January 20, 2010
U7-C-STP-NRC-100026

South Texas Project
Units 3 and 4
Docket Nos. 52-001
Response to Request for Additional Information

This letter provides responses to Request for Additional Information (RAI) Letter Numbers 3 and 4 related to the application to amend the ABWR DCD Part 2, Tier 2, Sections 5.2 and 7.7 provided in Attachment 1 to the referenced letter. This submittal completes the responses to these RAI letters.

FIGURE 6.2-39 ATMOSPHERIC CONTROL SYSTEM P&ID (Sheet 2 of 3)
 ABWR DCD/Tier 2 Rev.5

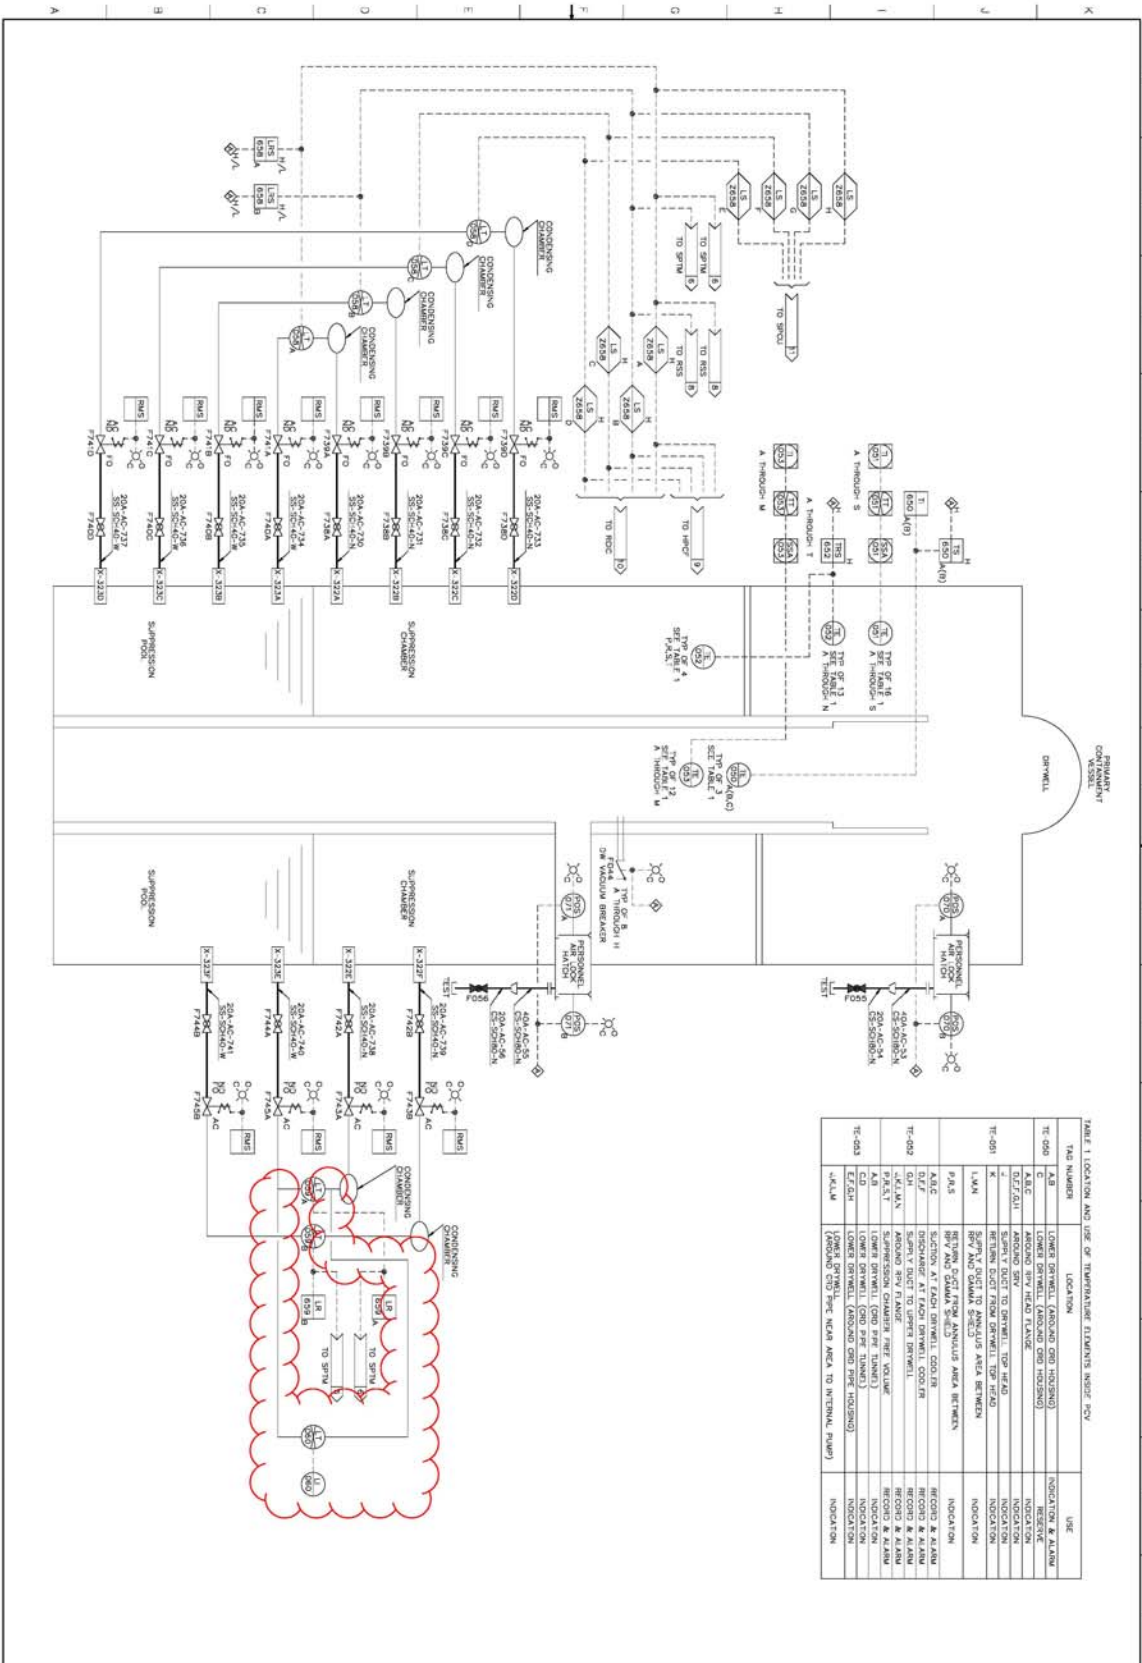
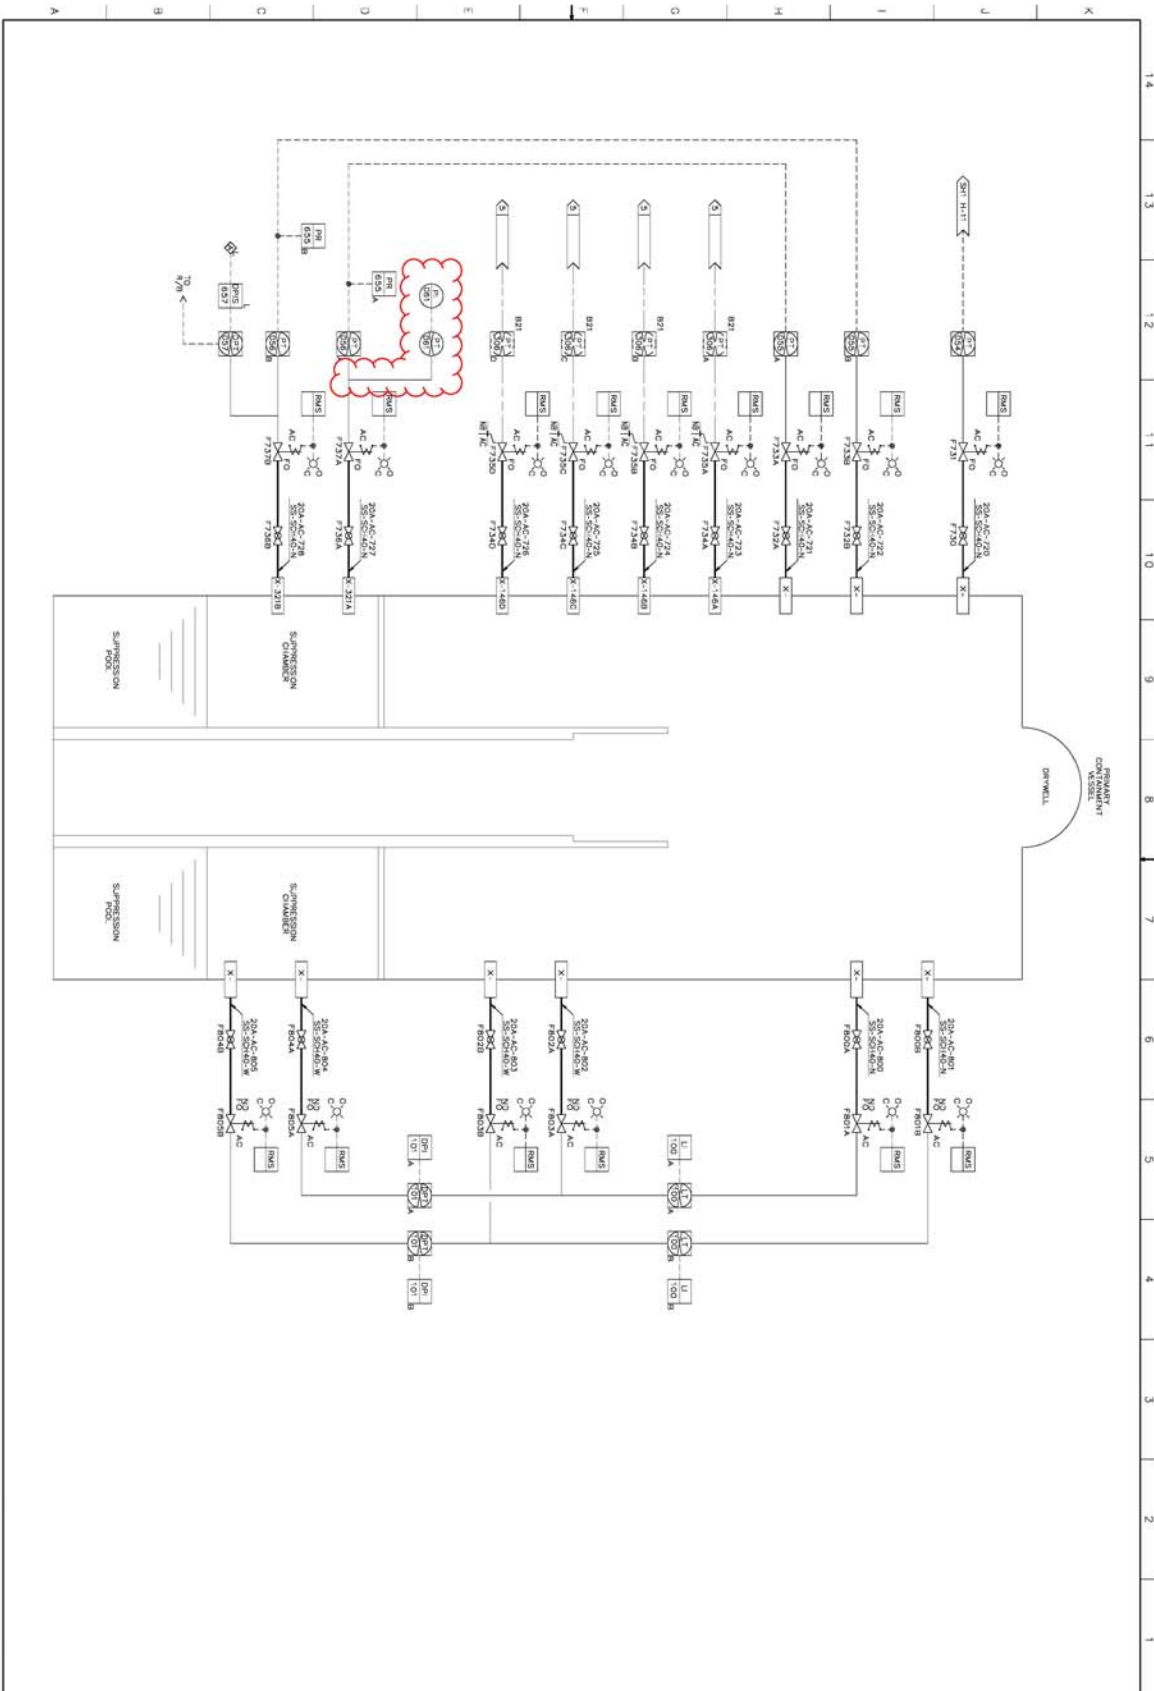
Subsection 7.7.1.1 of ABWR Design Certification Rule (DCR) application references Chapter 9.5.14 in the description of the reactor water level instrumentation provided for the Alternate Feedwater Injection System. Subsection 9.5.14.4 reads: “...*The instrument lines to be used for monitoring the alternate feedwater injection are branched from the existing line and are connected to new level and pressure transmitters*”.

GDC 24 “Separation of protection and control systems” reads “*The protection system shall be separated from control systems to the extent that failure of any single control system component or channel, or failure or removal from service of any single protection system component or channel which is common to the control and protection systems leaves intact a system satisfying all reliability, redundancy, and independence requirements of the protection system. Interconnection of the protection and control systems shall be limited so as to assure that safety is not significantly impaired*”.

The staff request the applicant to clarify how and where the connection is made from which the AFI system gets its instrumentation signals and to demonstrate that the instrumentation included in the new AFI system does not create any potential for inadvertent actuation or creates challenges to current safety systems.

The instrumentation connections for the AFI system are shown in the marked-up drawings for FSAR Figure 5.1-3, Sheet 5 provided in the original amendment submittal and in updated Figure 6.2-39, Sheets 2 and 3, attached to this RAI, which supersedes the Figure 6.2-39 markups provided in the original submittal. There are no automated control systems or functions for the AFI system, because it is a manually operated system. The instrumentation for the AFI system only includes indicators that are for operator information. In addition, the water level and pressure instrumentation in the AFI pump room uses separate transmitters and power supply from existing instrumentation. Consequently, the AFI system does not create any potential for inadvertent actuation or challenges to current safety systems.

FSAR Figure 6.2-39, Sheets 2 and 3 are changed as a result of this response.
